**ADDENDUM NO. 1**

**ROBLES-CASITAS CANAL  
DE LA GARRIGUE BRIDGE REPLACEMENT PROJECT  
Specification No. 18-398**

**ROBLES-CASITAS DIVERSION CANAL**  
STA. 24+05.47 TO STA. 298+98±  
CANAL SECTIONS AND LINING DETAILS

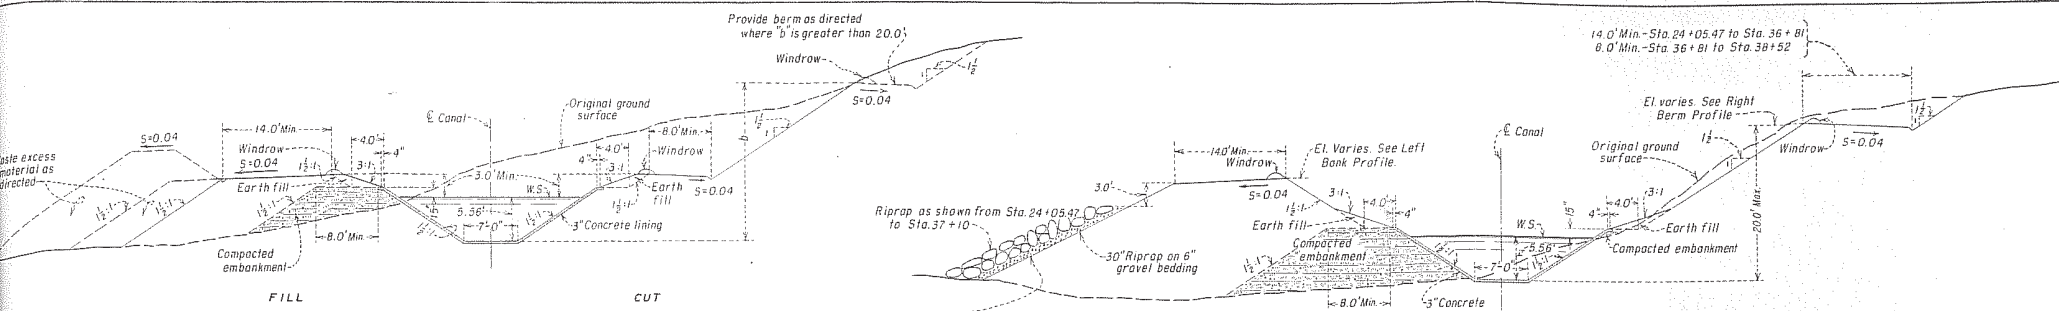
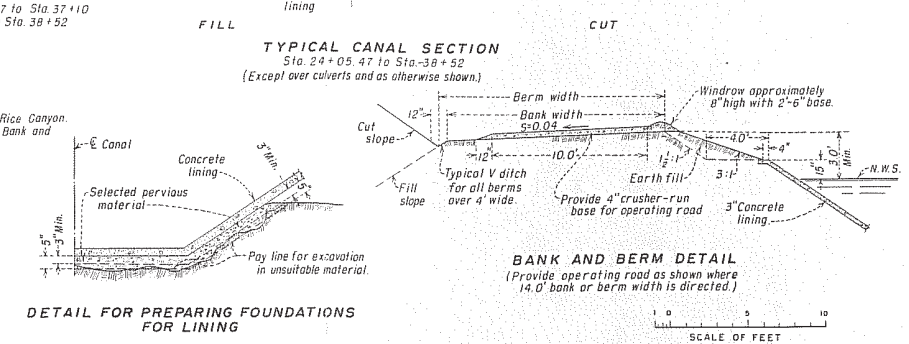
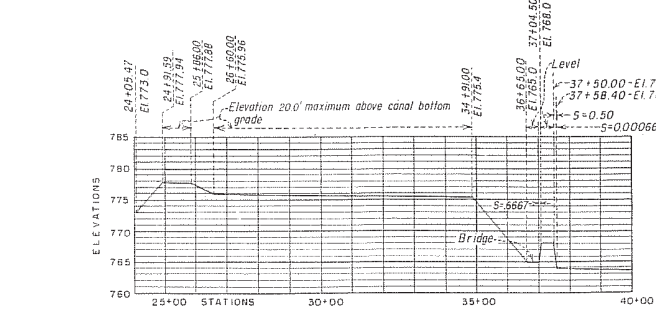
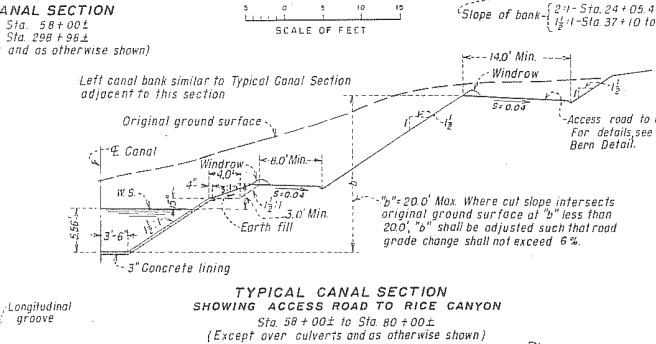
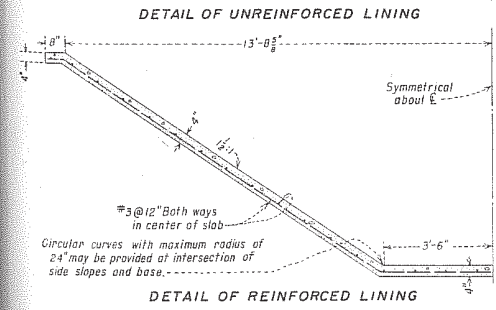
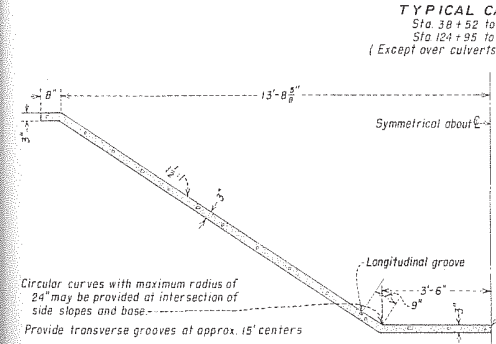
9. *Q: Can you provide as-built drawing of the existing channel at the location of the existing crossing?*

A: The as-built drawing is attached to this Addendum (Drawing No. 767-D-133)
